Access Compliance Report

Public Rights-of-Way

(Pedestrian Signals)

Intersection ID: N/A	Main Street:	Cross Street: N/A	Location: N/A
ADA ID: A6DE5BA68E98	Signal Type: One Push Button-Non APS	Overall Compliance: No	Severity Score: BTN 1: N/A BTN 2: N/A No BTN: N/A
Codes/Mitigation Info/Possible Solution		Field Measurements/Component Compliance

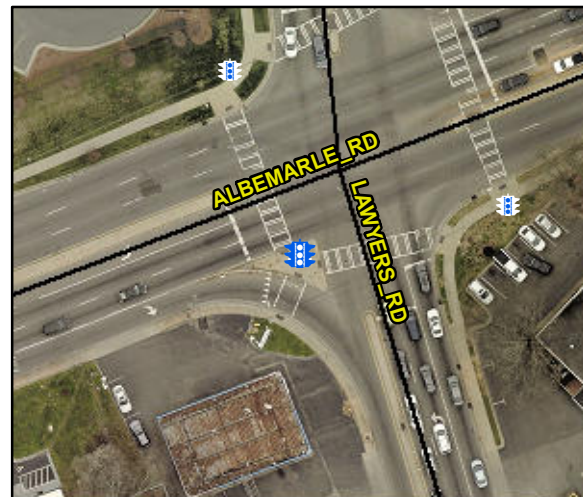
Possible Solutions: Remove & Replace Sign. Provide Push Button Extension. Remove and Replace Clear Space.

Surveyor Notes: TEXT HT 1/2

PROW/ADA: R410.6, R404.2, R404.3, R406.2
